## **AGENDA**

- C. Case File: #2-VAR-PC-21  
Applicant: Mark Lisac  
Application: Development in Retail Commercial C-1 Zone. Request for Variances: Sidewalks, Pedestrian Amenities, Building Main Entrance Orientation, Parking  
Zone, Map and Tax Lot: Retail Commercial C-1  
09-11-05-CD #02800, #03100, #03200, #03300, #03301, #03400  
Location: NW corner intersection HWY 101 and NE Bradford Street

1 Depoe Bay Planning Commission  
2 Regular Meeting  
3 Wednesday, October 13, 2021 – 6:00 PM  
4 Depoe Bay City Hall  
5

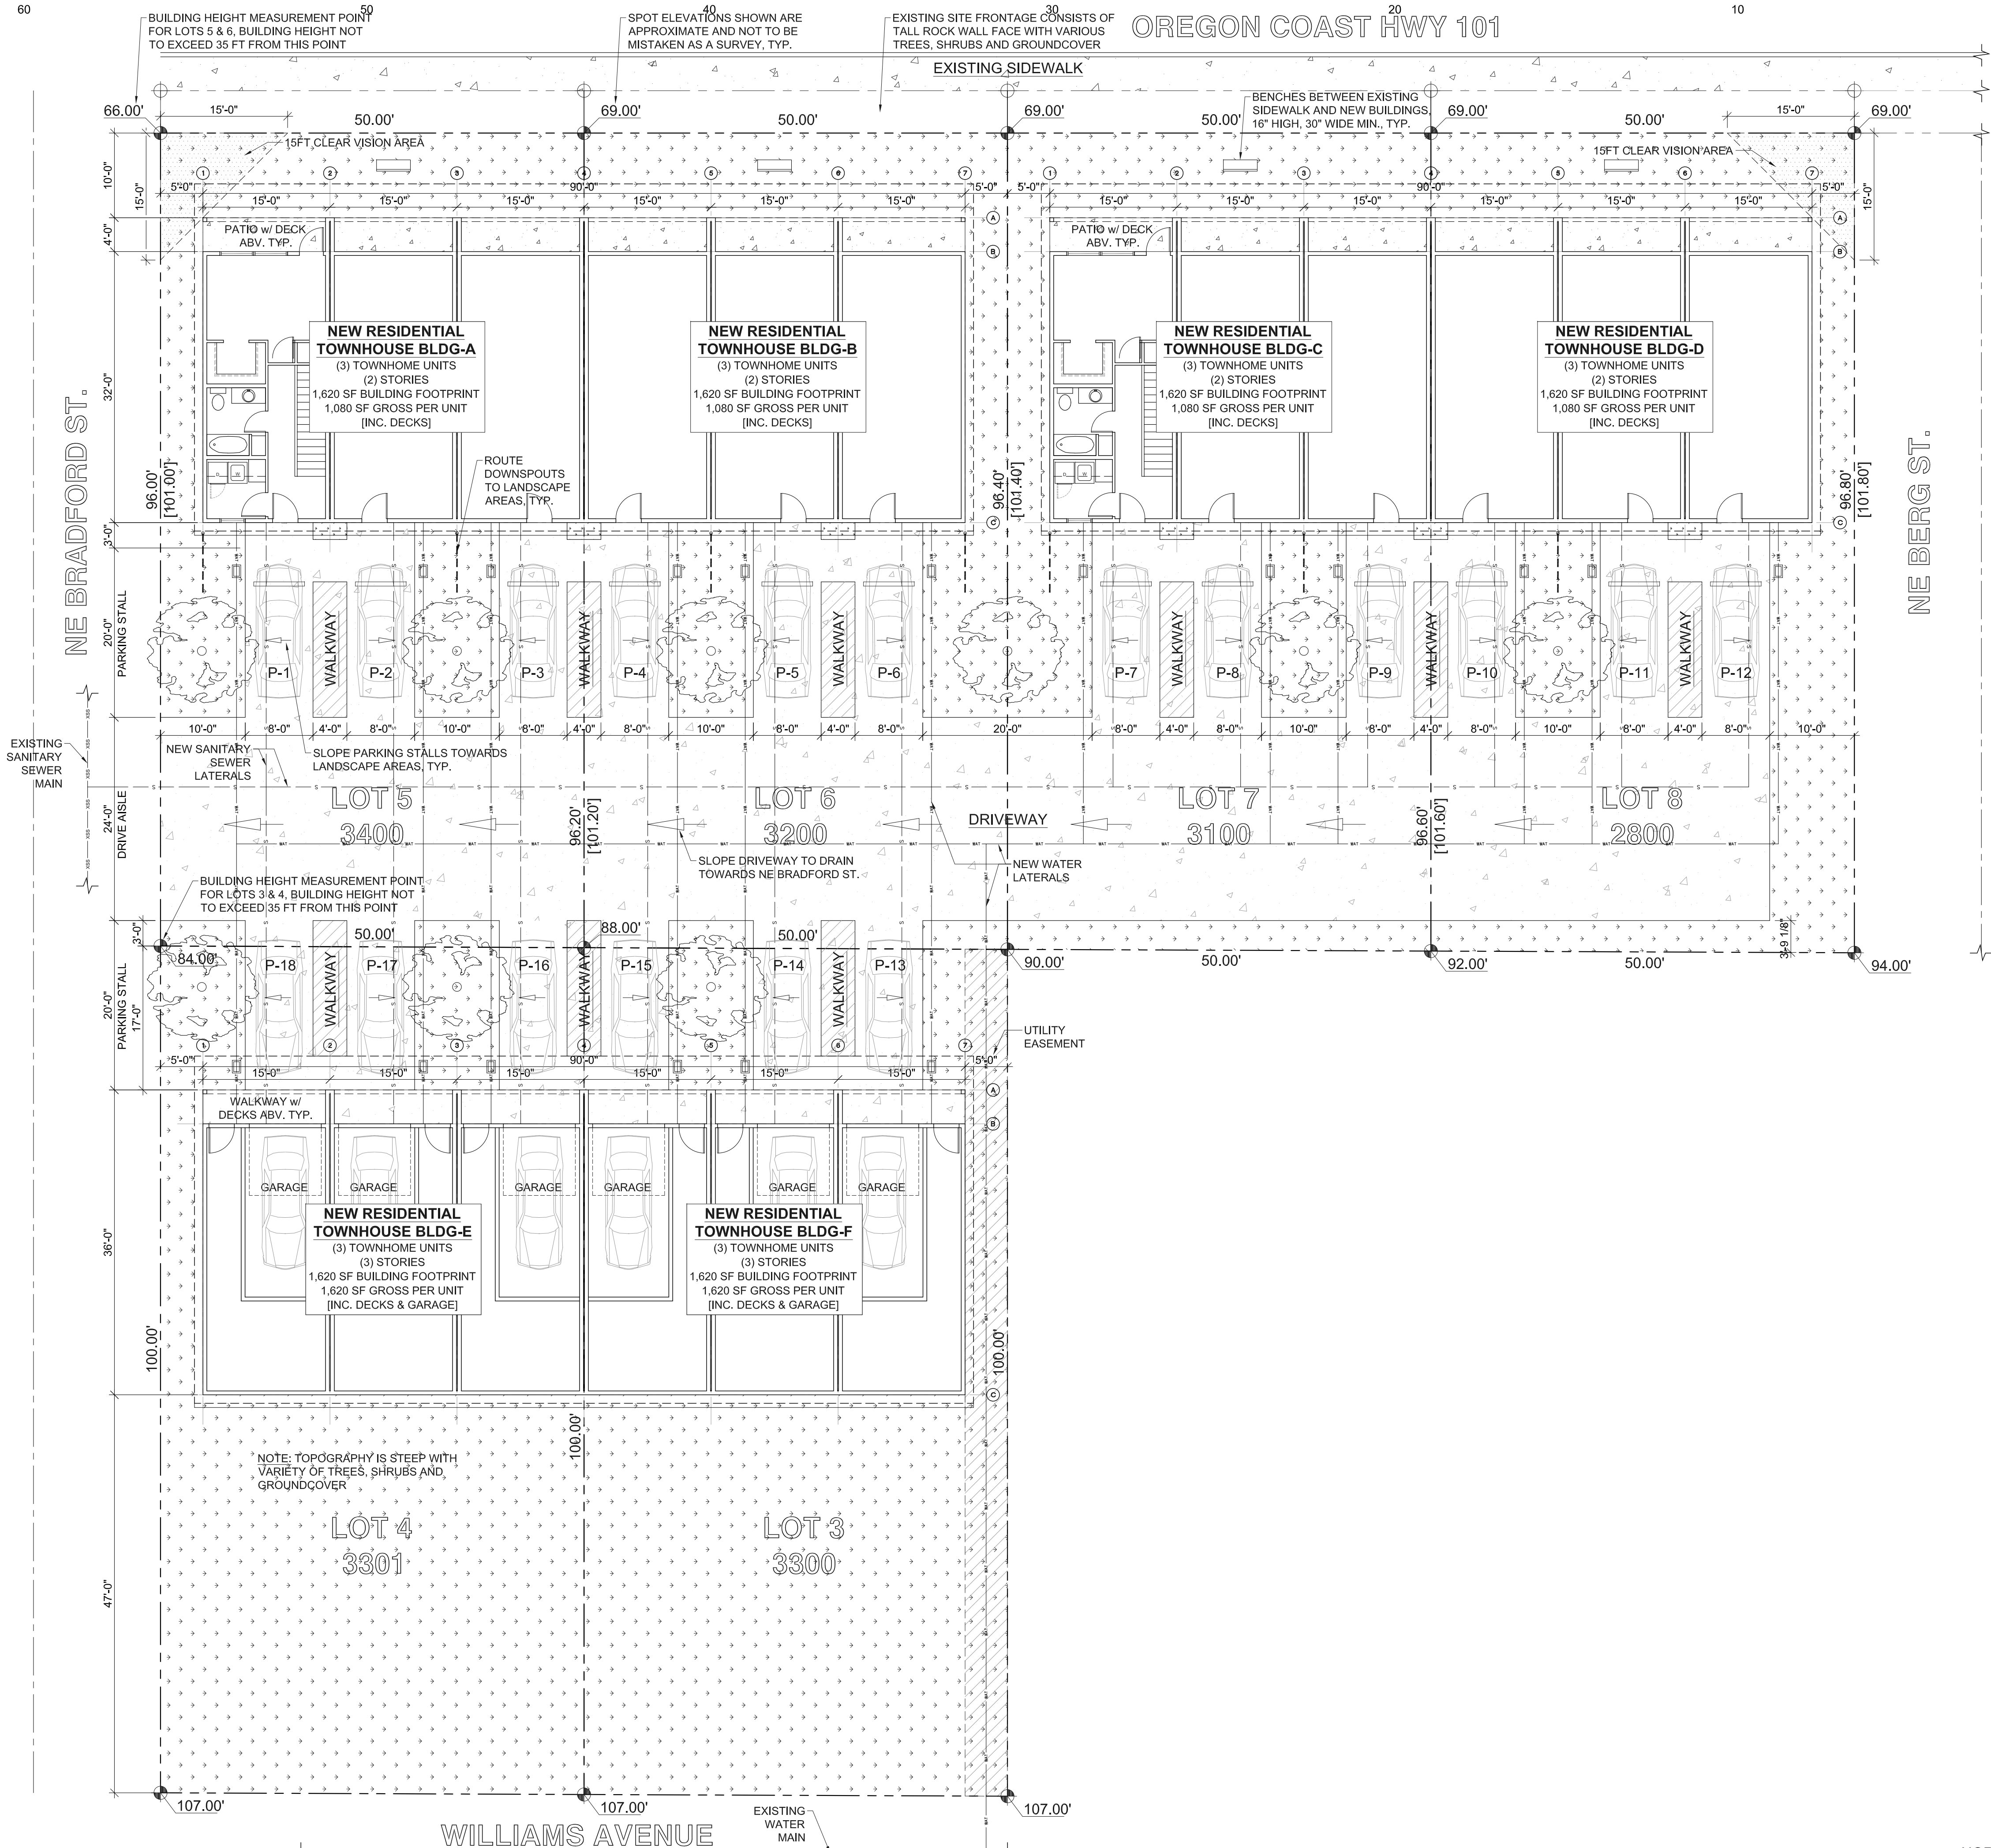
We are strongly in favor of using this opportunity to improve this part of Williams Avenue. See photo below showing (from our driveway looking down) the current convergence of driveways just as Williams narrows; we assume the location of driveways for the new dwellings will increase an already dangerous situation unless Williams is widened.

Williams narrows just on the other side of the trees on the left side of this photo. This photo is taken from 120 Williams driveway, looking down onto Williams; just past the current convergence of driveways is where it narrows to one lane. Adding 18 dwellings must include attention to Williams Avenue in our opinion.
